# Access Compliance Report

### (Curb Ramps)

Intersection ID: 10067	Main Street: ETHEL_GUEST_LN	Cross Street: OAKLAWN_AV	Location: NW
ADA ID: 451E78D5DC31	Ramp Type: PerpDiag	Initial Pass/Fail: Fail	Overall Compliance: No
Severity Score: 12.5			
Codes/Mitigation Info/Possible Solution		Field Measurements/Component Compliance

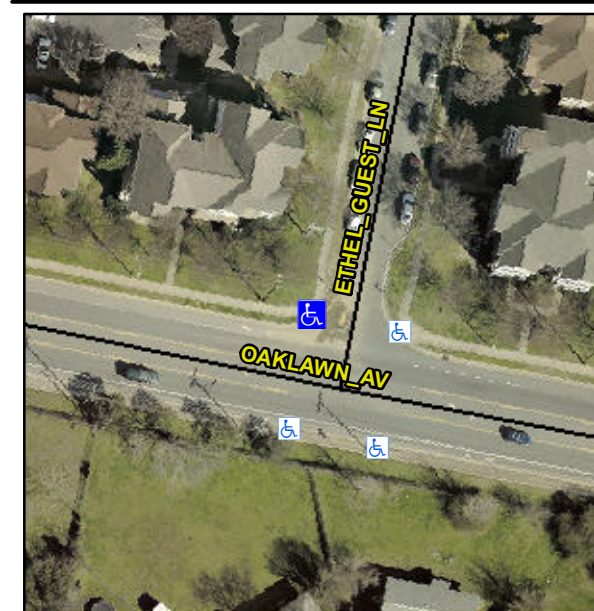
**Not Found, R304.2.2**

Compliance	Description	Data	Compliance	Description	Data
N/A	Ramp Length (in)	45.0	No	Ramp Slope (%)	10.2
Yes	Ramp Width (in)	54.0	Yes	Ramp XSlope (%)	1.9
N/A	Flare Type LT	N/A	N/A	Flare Type RT	N/A
N/A	Flare Slope LT (%)	N/A	N/A	Flare Slope RT (%)	N/A
N/A	Flare Traversable LT?	N/A	N/A	Flare Traversable RT?	N/A
N/A	Landing Length (in)	N/A	N/A	DWS Provided?	N/A
N/A	Landing Width (in)	N/A	N/A	DWS Contrast?	N/A
N/A	Landing Slope (%)	N/A	N/A	DWS Length (in)	N/A
N/A	Landing X Slope (%)	N/A	N/A	DWS Full Width?	N/A
N/A	Landing Curb? (Y/N)	N/A	N/A	DWS Offset (in)	N/A
N/A	Shared Landing?	N/A			
N/A	Gutter Ponding?	N/A	N/A	Gutter Slope (%)	N/A
N/A	Gutter Lip Ht (in)	N/A	N/A	Gutter X Slope (%)	N/A
N/A	Painted X Walk1?	No	N/A	Painted X Walk2?	No
	X Walk 1 Direction	To SW		X Walk 2 Direction	To SE
N/A	X Walk 1 Width (in)	N/A	N/A	X Walk 2 Width (in)	N/A
	X Walk 1 Slope (%)	3.3		X Walk 2 Slope (%)	2.9
	X Walk 1 X Slope (%)	1.3		X Walk 2 X Slope (%)	4.8

**Remove & Replace Curb Ramp With Two New Directional Ramps or Equivalent.**
